PINECREST EAST SUBDIVISION

APPLICATION NUMBER 12 DATE June 6, 2013
APPLICANT Pinecrest East Subdivision
REQUEST Subdivision

DETAIL SITE PLAN

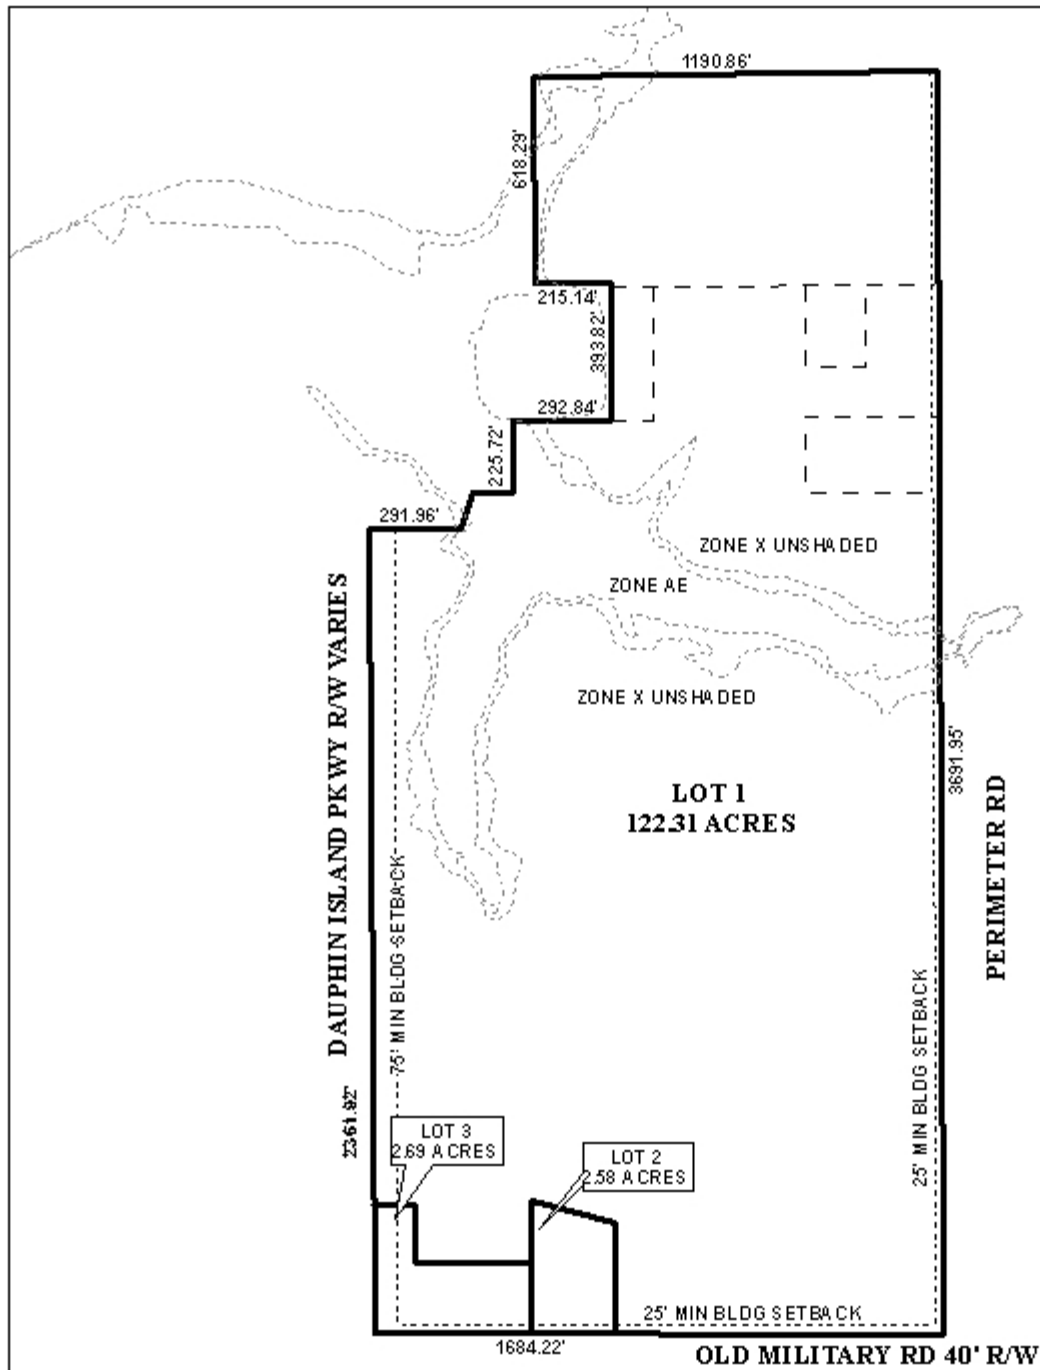
Engineering Comments: The following comments should be addressed prior to review, acceptance and signature by the City Engineer: 1. provide all of the required information on the Final Plat (i.e. signature blocks, signatures, certification statements, legal description, required notes); 2. dedicate a radius (minimum 25' radius) at the corner of Gatokoco Rd (Old Military Road). The final location and size to be approved by the City Engineer and Traffic Engineer; 3. it appears that there is a discrepancy between the legal description and the boundary at the southeast corner of LOT 1. Has the 25' radius been previously dedicated, or is it being dedicated with the recording of this subdivision? 4. What kind of monument was found or set at the Point of Beginning (southwest corner of LOT 3)?

The proposed Lot 3 fronts Dauphin Island Parkway and Gatotkoco Drive (Old Military Road). Dauphin Island Parkway is a major street as shown on the Major Street Plan Component of the Comprehensive Plan. The Plan requires a right-of-way width of 100-feet for Dauphin Island Parkway and the preliminary plat illustrates a variable right-of-way. Therefore, the provision of a setback sufficient to provide 75-feet from the centerline of Dauphin Island Parkway, would be required. Gatotkoco Drive is a minor street, provided with curb and gutter, requires 50-foot right-of-way, the preliminary plat illustrates 40-feet of right-of-way. Section V.B.14. of the Subdivision Regulations requires minor streets provided with curb and gutter to have a minimum right-of-way of 50-feet. Additionally, Section V.B.16. of the Subdivision Regulations requires a minimum curb radius at intersecting streets. As such, dedication sufficient to provide 25 feet from the centerline of Gatotkoco Drive (Old Military Road) and compliance with Section V.B.16., in regards to curb radii should be required at the intersection of Dauphin Island Parkway and Gatotkoco Drive (Old Military Road).

- 1) provision to provide 75-feet setback from the centerline of Dauphin Island Parkway;
- 2) dedication to provide sufficient right-of-way to provide 25-feet from the centerline of Gatotkoco Drive (Old Military Road);

- 3) dedication of sufficient radius at the intersection of Dauphin Island Parkway and Gatotkoco Drive (Old Military Road), to be approved by City Engineering and Traffic Engineering and conform to AASHTO standards;

- 5) the subdivision process be completed prior to the issuance of any permits;
- 6) illustration of the 25-foot minimum building setback line along Gatotkoco Drive (Old Military Road);
